Re: The Hub at Tucson III (No. T17SA00305) – March 2018 Design Package Changes

THE HUB AT TUCSON III

DESIGN PACKAGE - CHANGE SUBMISSION I **CHANGES TO OCTOBER 3, 2017 APPROVED DESIGN**

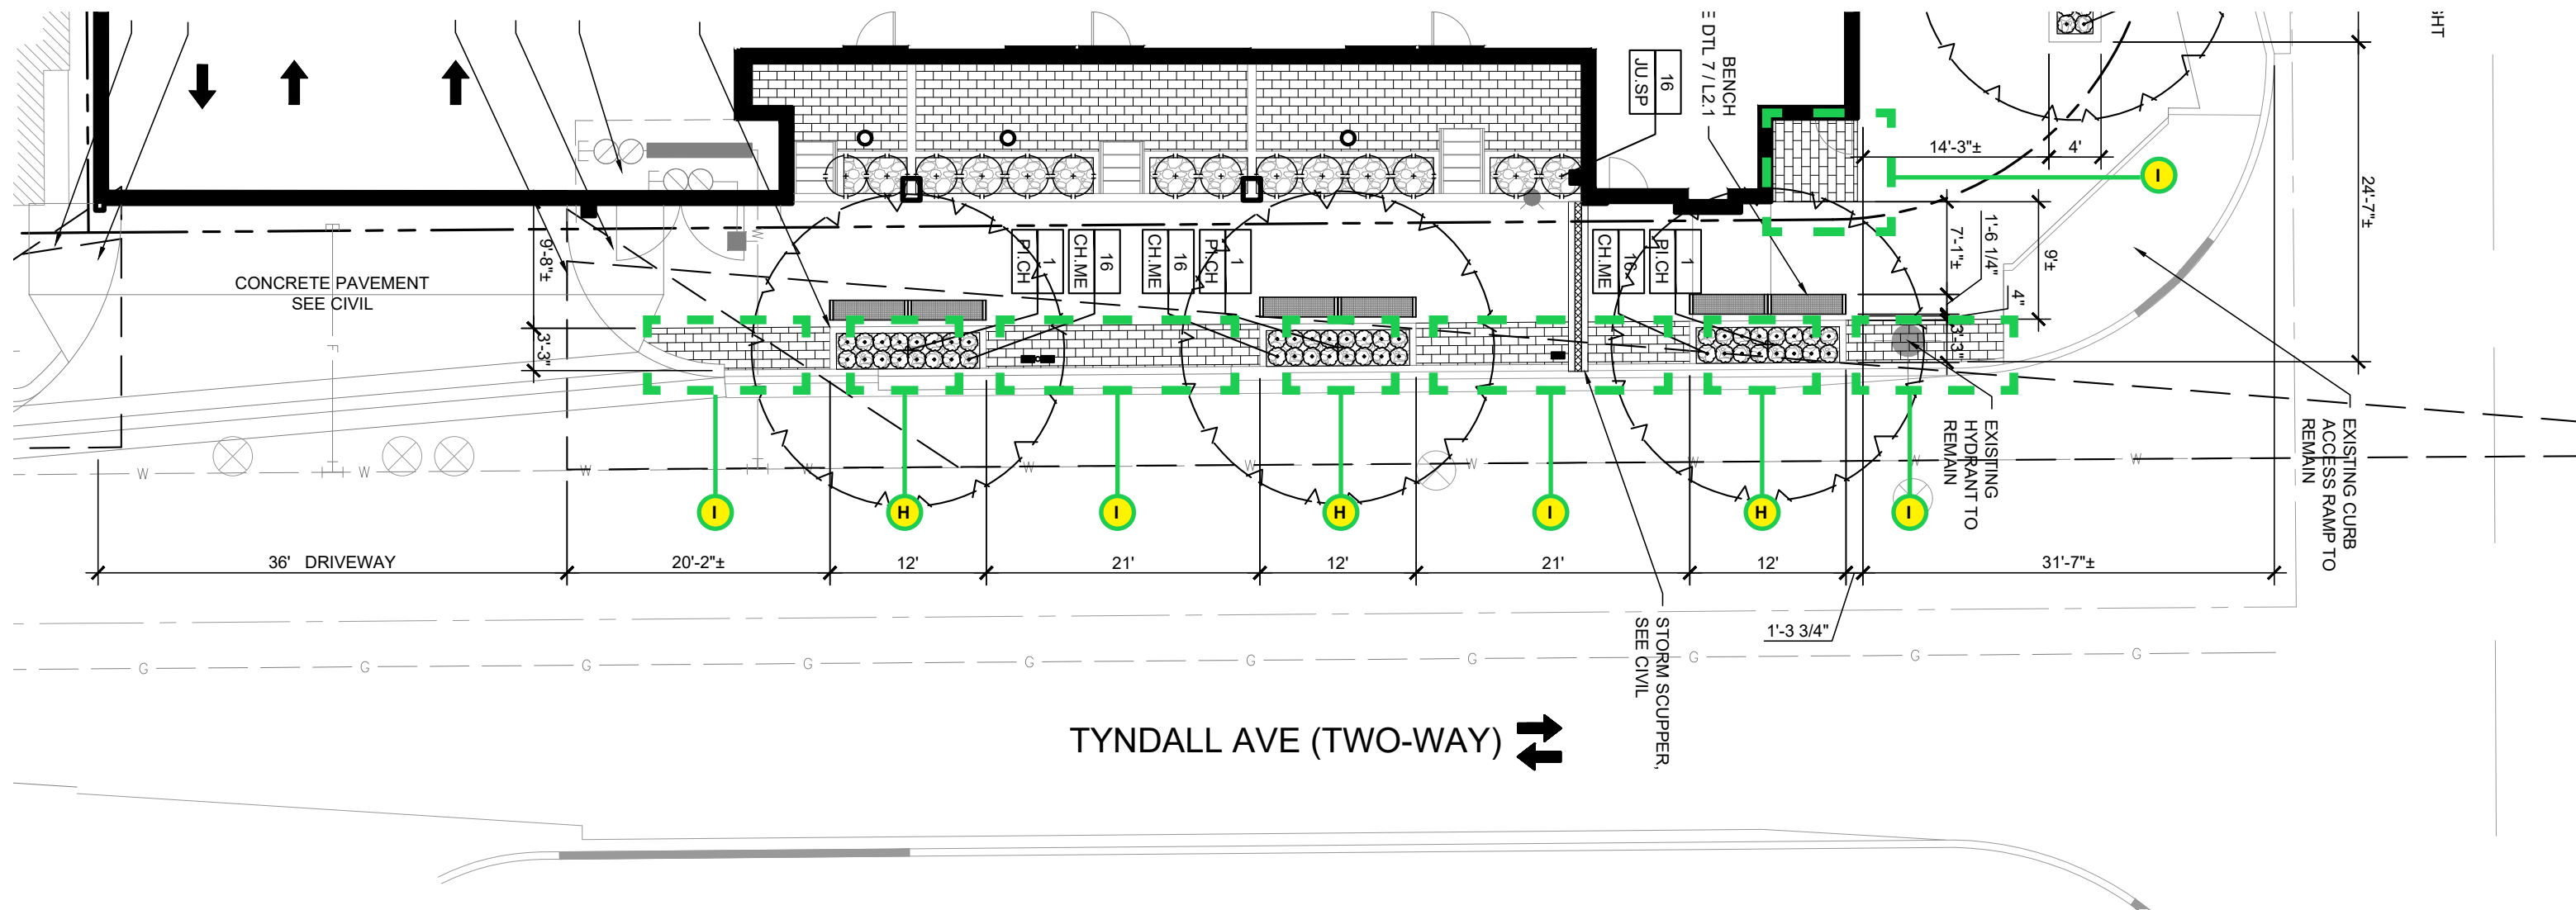
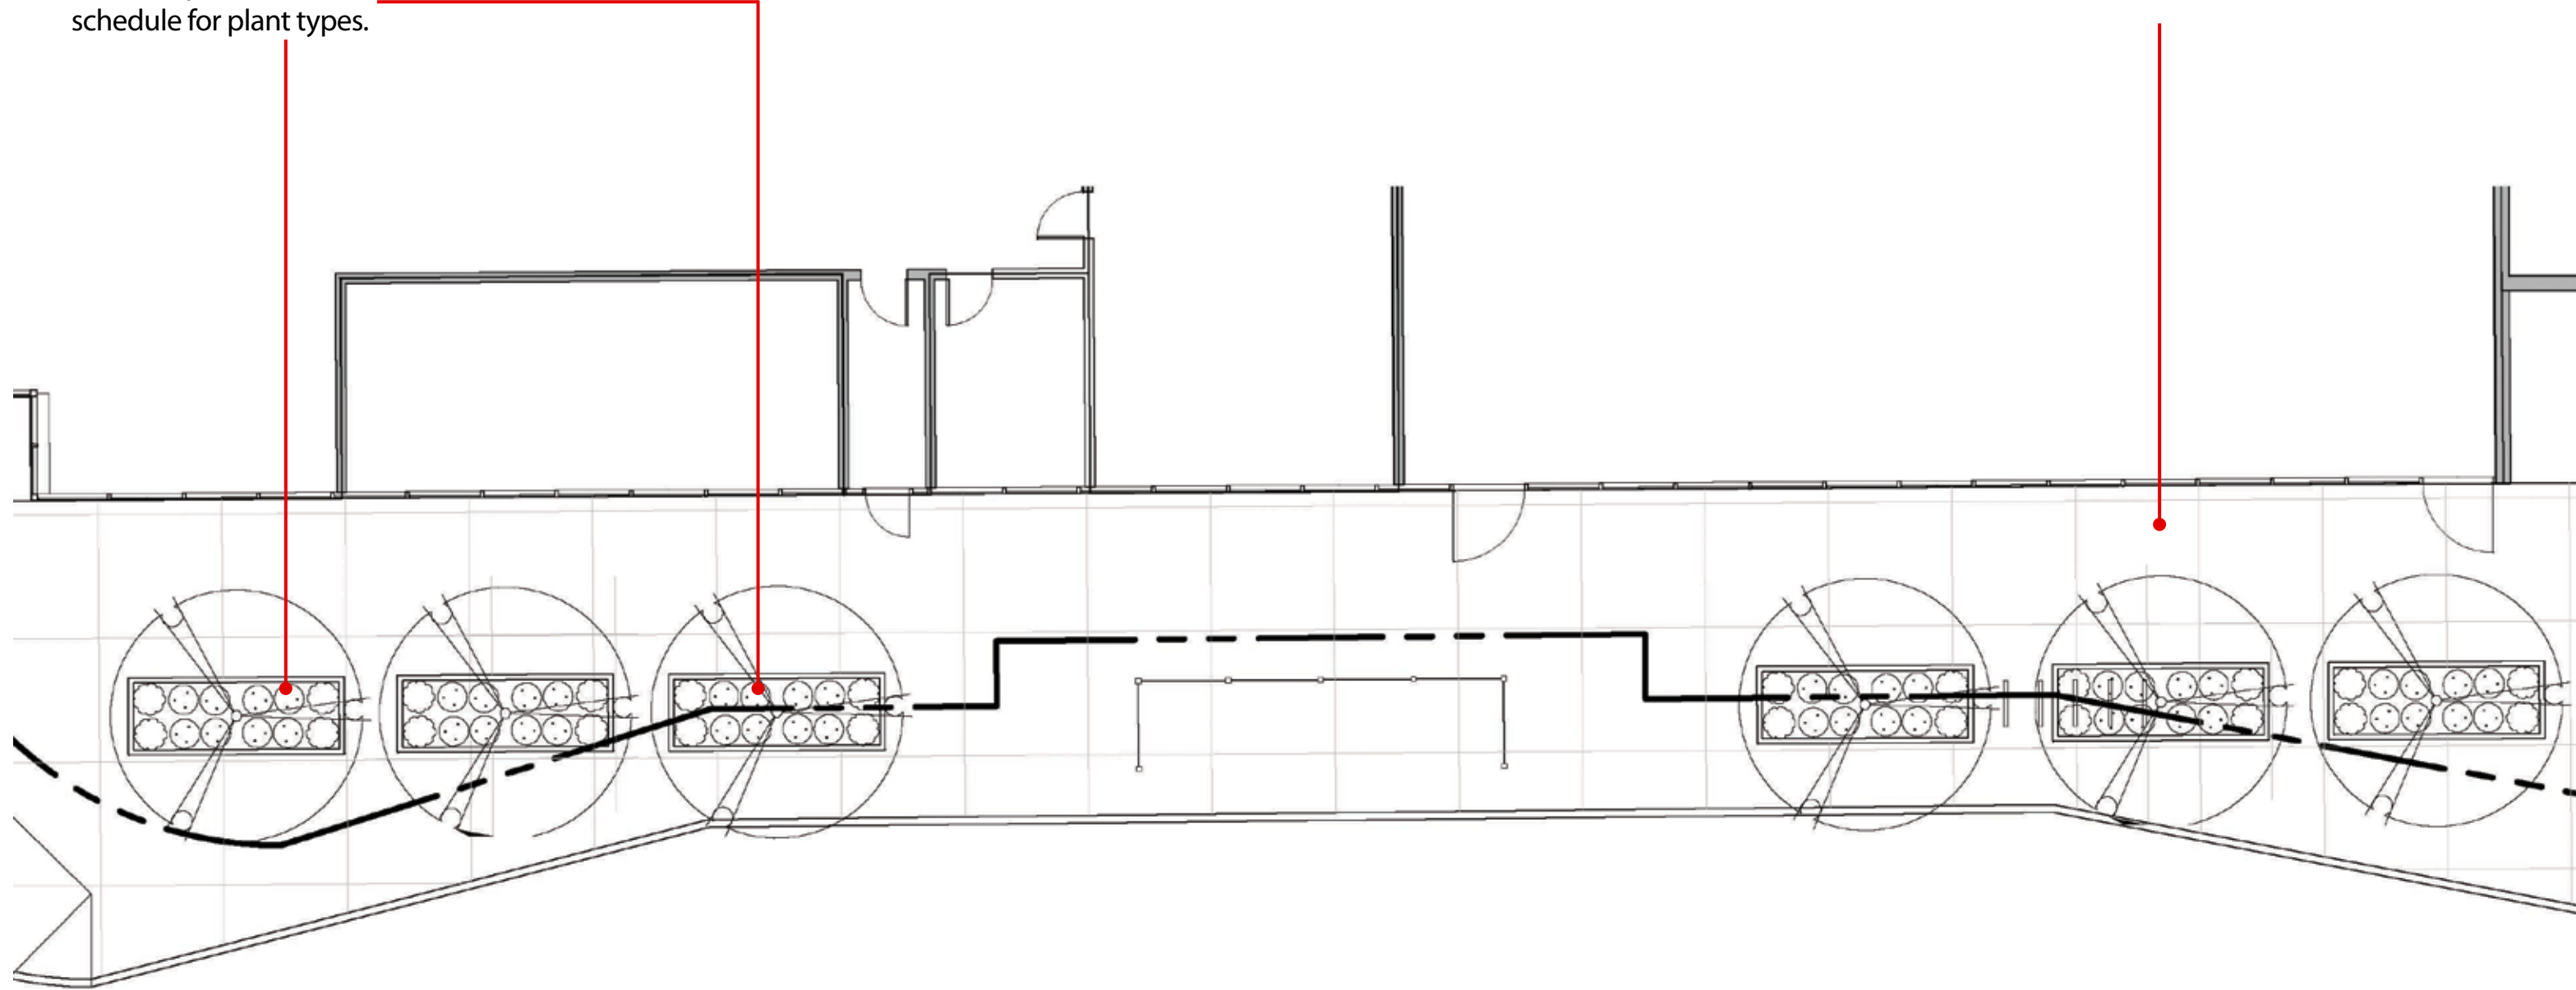
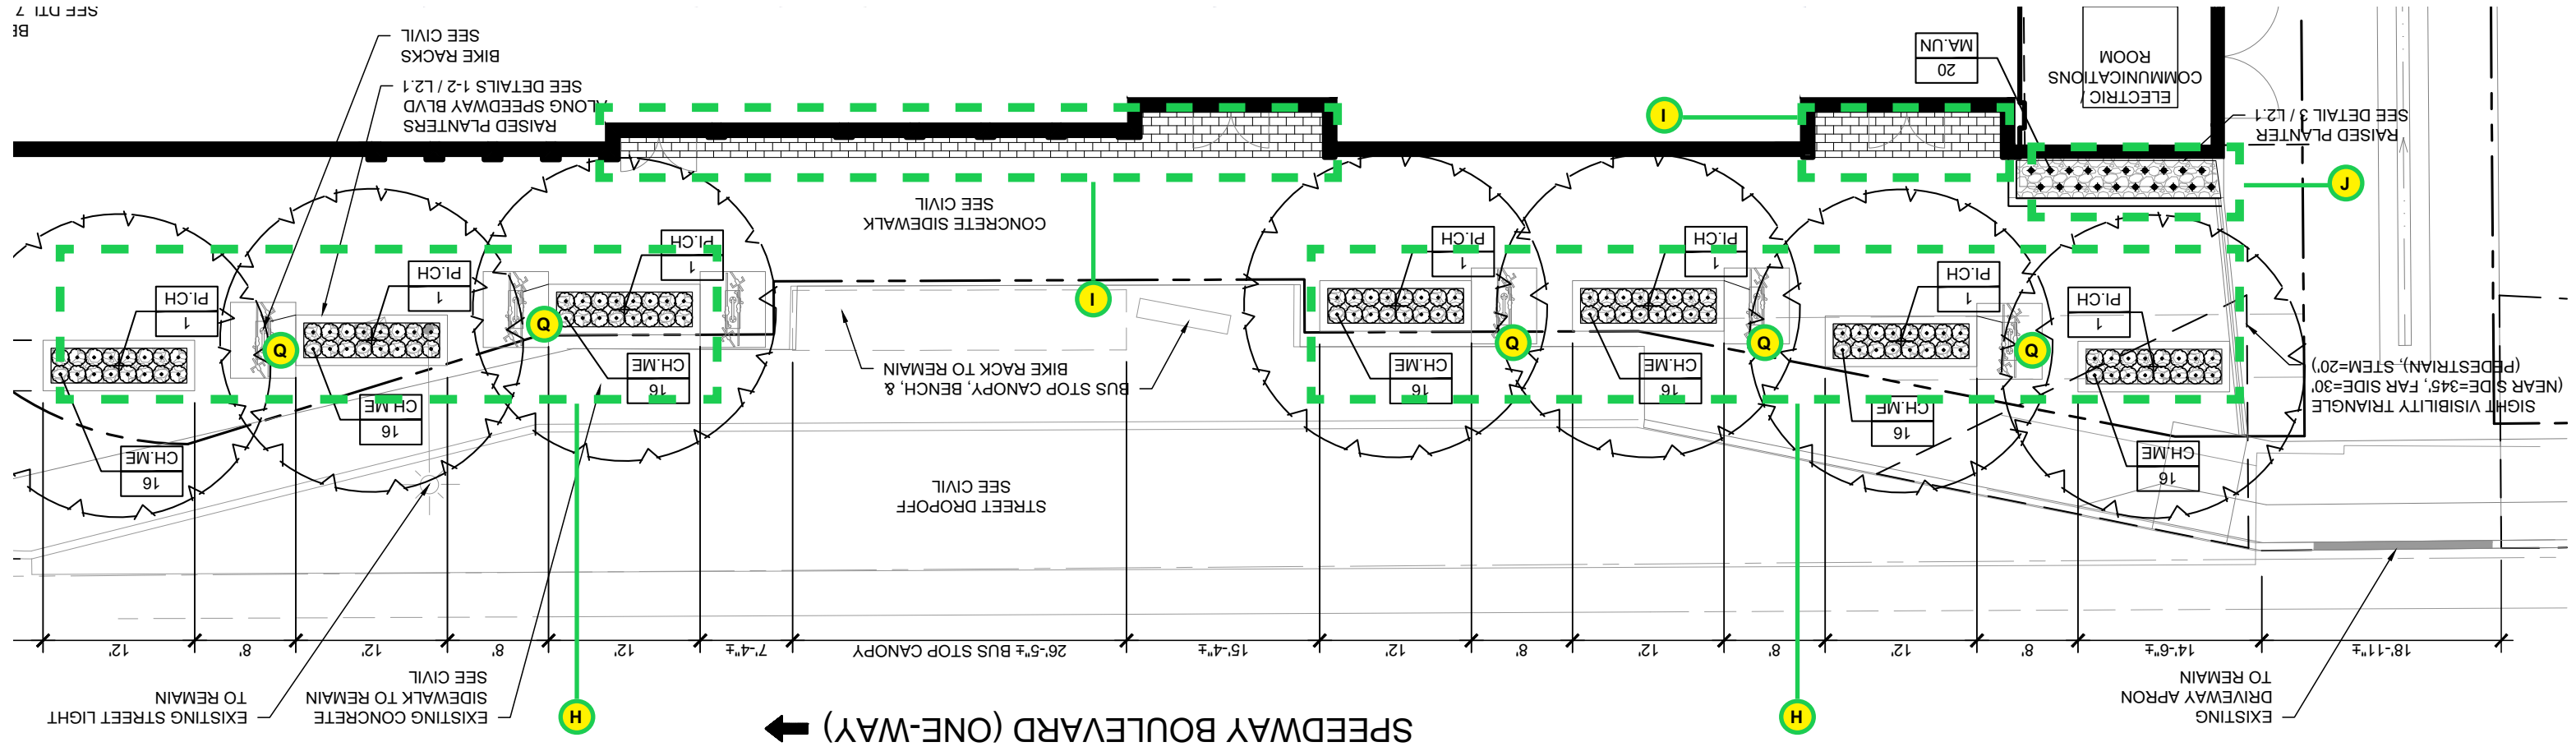
- **H** - Landscape alterations at streetcape. Planters along Speedway Ave, follow the curb cut out of the bus stop. Planters along Tyndall Ave have moved to curb edge.

- **I** - Concrete Pavers have been added along Tyndall Ave and Speedway Ave to enhance the streetscape.
- **J** - Planter in front of Transformer enclosure is bigger.

8. Landscape Planter Alignment (Item H): The landscape planters at the Project's streetscape have been adjusted, as follows:
 - *Speedway*: The raised planters along Speedway have been repositioned and staggered to follow the contour of the bus pullout. This minor location change allows for additional pedestrian clearance between the planters and the Project walls. The number of planters (including trees) will not change. This is a minor change that improves the functionality of the pedestrian space in the front of the Project.

- *Tyndall*: The raised planters along Speedway have been moved towards the street approximately six inches so they are flush with the back edge of the curb. This eliminates an unnecessary strip of concrete between the planter and curb, and shifts that space to the main pedestrian walkway where it is useful. This is a very minor change that has no impact on the Project's overall design.

9. Concrete Paver Accents Added (Item I): Concrete accent pavers have been added in two areas within the Project's streetscape (but outside of the main pedestrian walkways), as follows:

- *Speedway*: Concrete pavers have been added to the entrances to the Project's retail storefronts. This is a design improvement that accents the retail areas and differentiates the retail entrances from the other parts of the streetscape.

- *Tyndall*: Concrete pavers have been added to the area between the Tyndall frontage planters. This is a design improvement that accents the areas between
